FED. ROAD DIST. NO.	STATE	PROJ. NO.	FISCAL YEAR	SHEET NO.	TOTAL SHEETS
HAWAII	HAW.	HWY-K-01-13M	2013	ADD.7	18

STATE OF HAWAII DEPARTMENT OF TRANSPORTATION HIGHWAYS DIVISION	
<u>TRAFFIC SIGNAL LEGEND & DETAILS</u>	
<u>KUHIO HIGHWAY</u>	
<u>Traffic Signal Rehabilitation</u>	
<u>at Various Locations</u>	
<u>Project No. HWY-K-01-13M</u>	
Scale: Not to Scale	Date: May, 2013
SHEET No. 1 OF 1 SHEETS

ADD.7

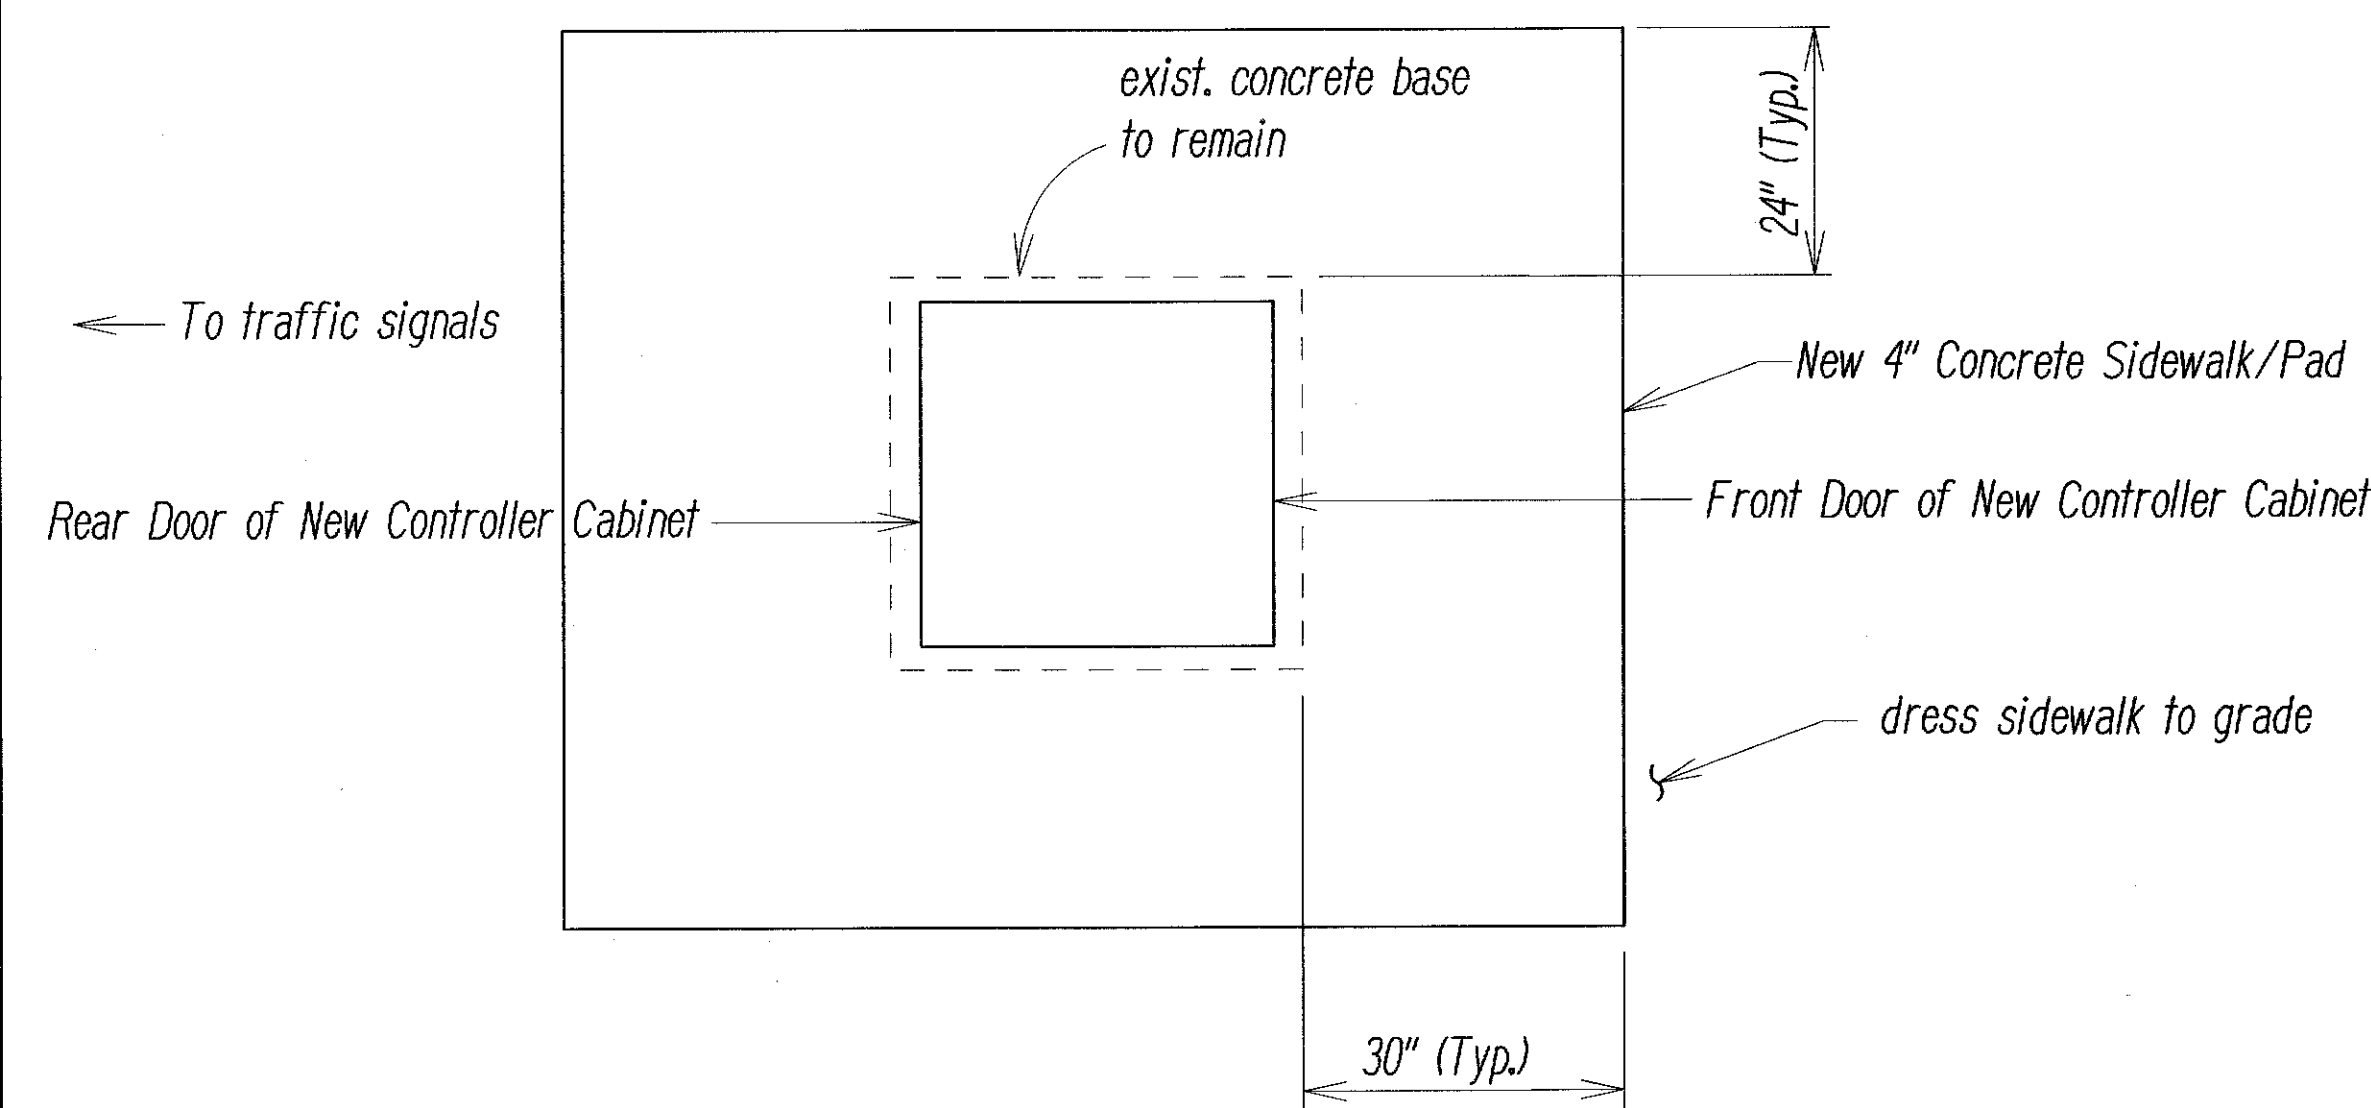
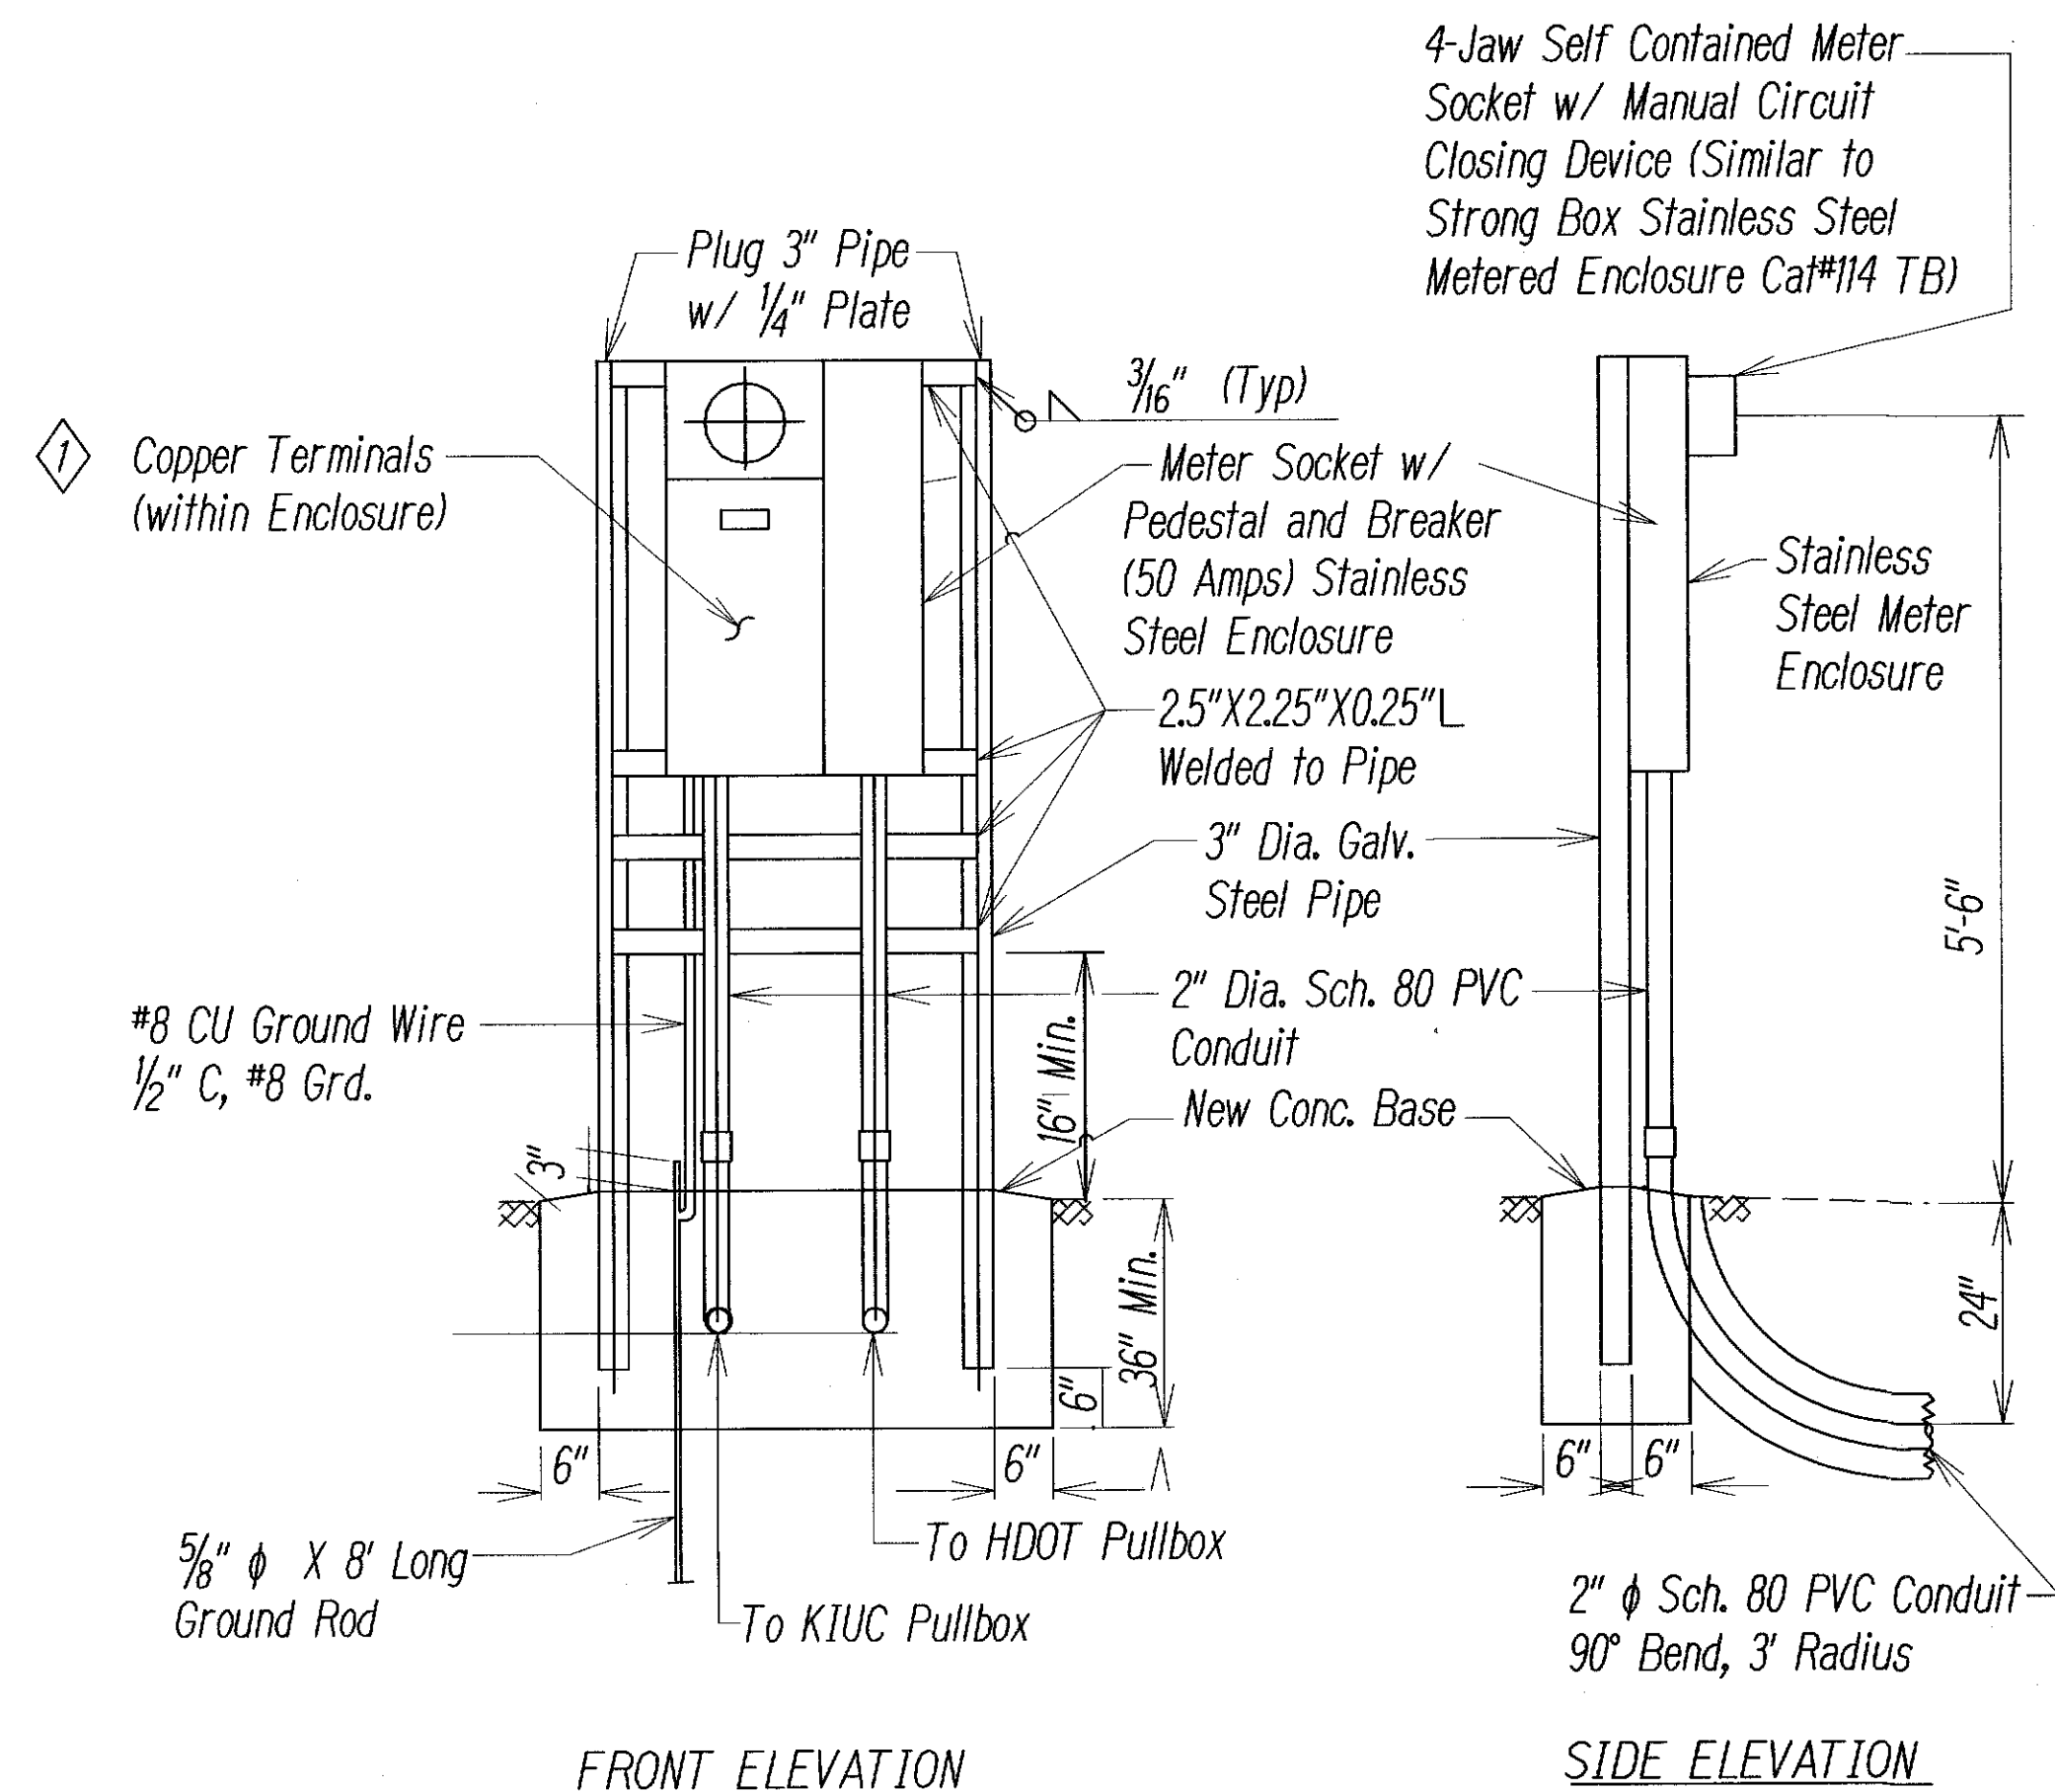
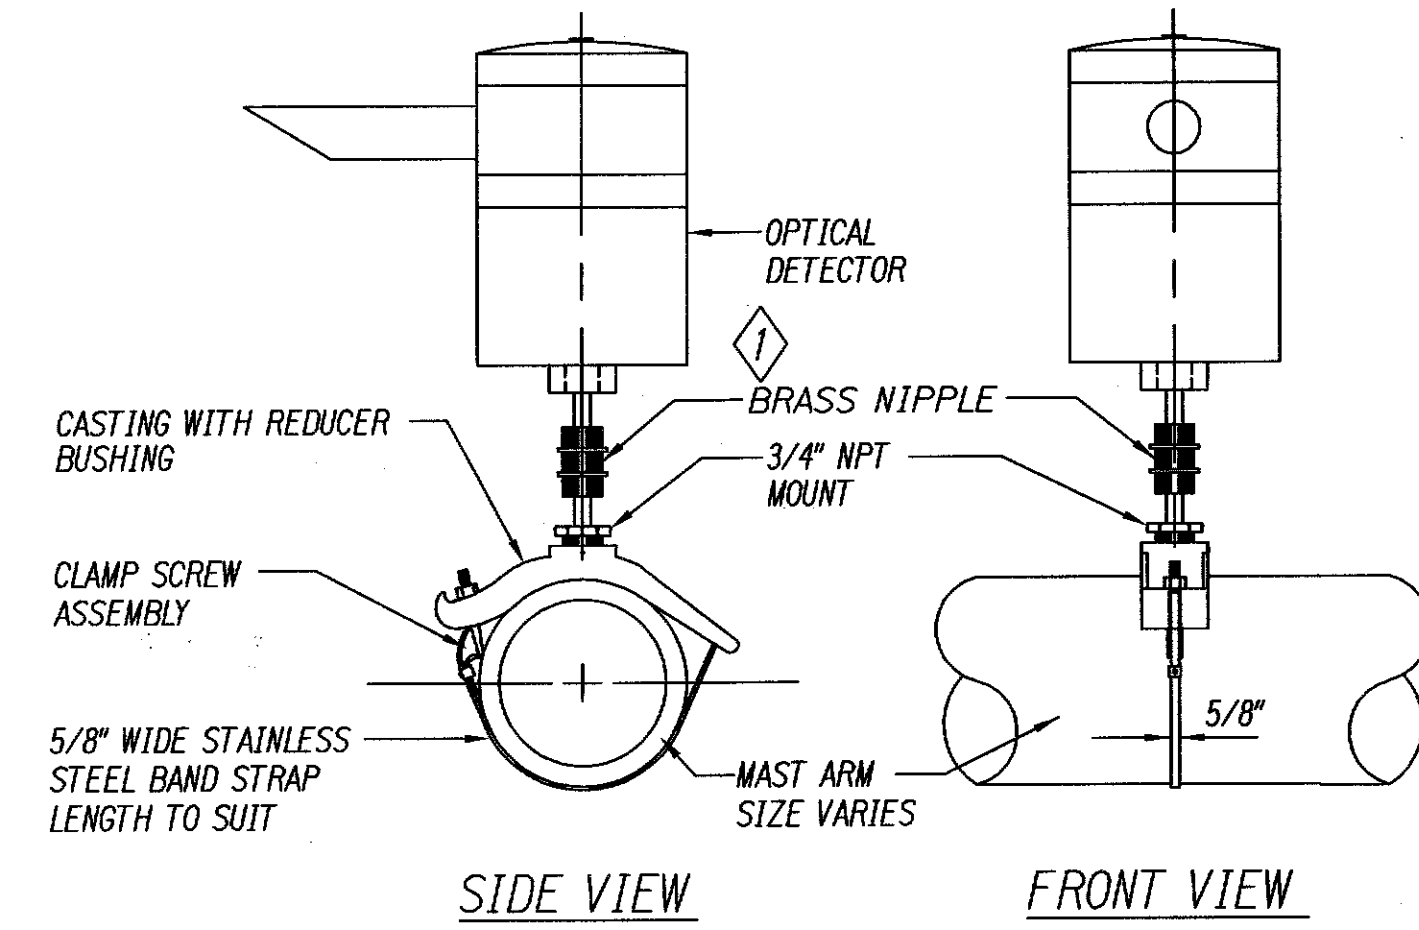
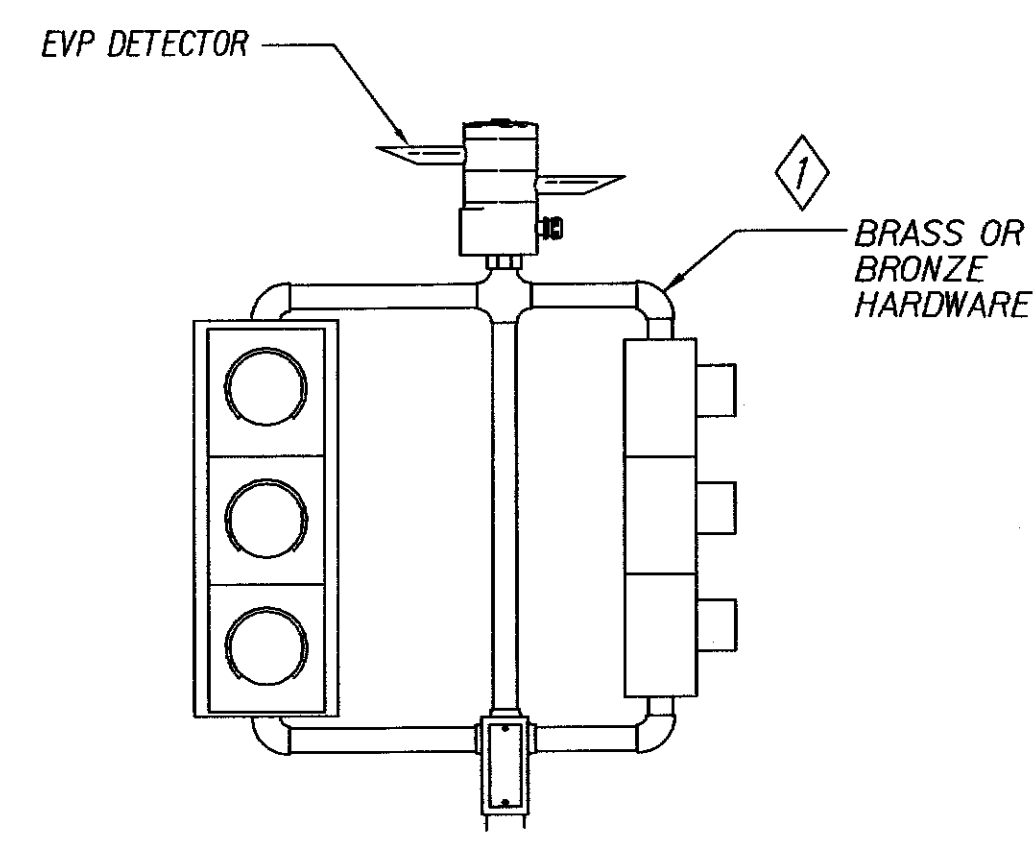
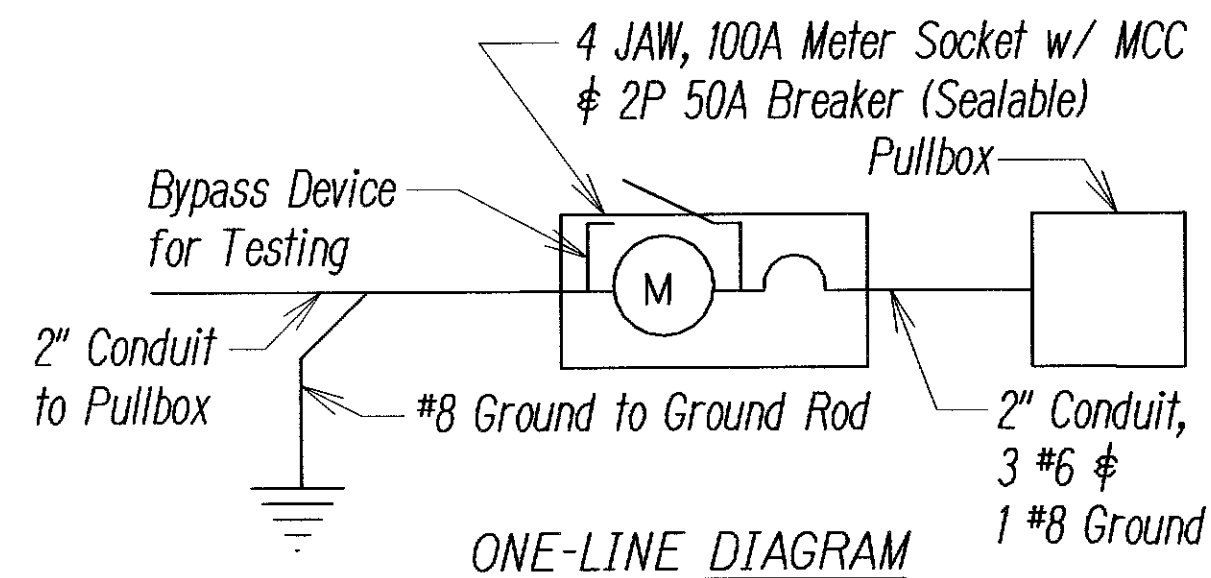
6/14/13	①	Revised Notes.
	①	Added Notes 7 and 8.
	①	Added Call-outs to Details.
DATE	REVISION

- NOTES:
1. Pedestal shall be new, hot-dipped galvanized after fabrication.
 2. All fastening bolts, nuts, and washers shall be new, stainless steel.
 3. Concrete base for meter pedestal shall be new. Remove portions of conduits, re-route to new pedestal with new conduit splices. Remove and demolish old pedestal and concrete base, backfill and compact immediately following removal.
 4. Provide 4 feet minimum clearance in front of meter.
 5. Install new pull box in the same location and on the same day as removal of old pull box.
 6. Contractor shall notify KIUC at least 5 days in advance to schedule disconnect/reconnect of meter socket. Please call 246-4334 to schedule work.
 7. All signal head mountings shall be brass or bronze.
 8. Remove existing, and replace with new pullboxes shall be performed at Locations 1 through 4 only (refer to Title Sheet 1 through 8, except as noted).
